HYUNDAI Technical Service Bulletin	GROUP FUEL SYSTEM	NUMBER 18-FL-003
	DATE JUNE, 2018	MODEL VELOSTER (FS)
SUBJECT: AIR DRAIN CASE REPLACEMENT

This bulletin provides the procedure to replace the Air Drain Case (also referred to in past as canister vent filter).

Parts Information:

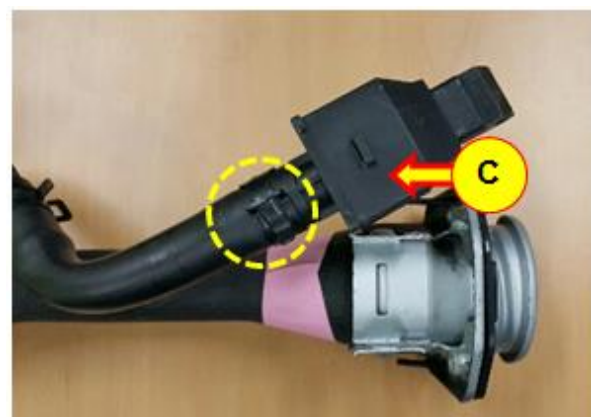
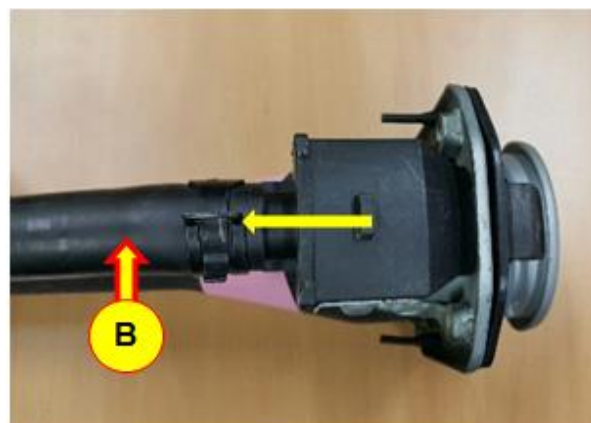
PART NAME	FIGURE / PART NUMBER		QTY.
	PREVIOUS	NEW	
Air Drain Case			1 each
	31035-2K500	31035-B2500FFF
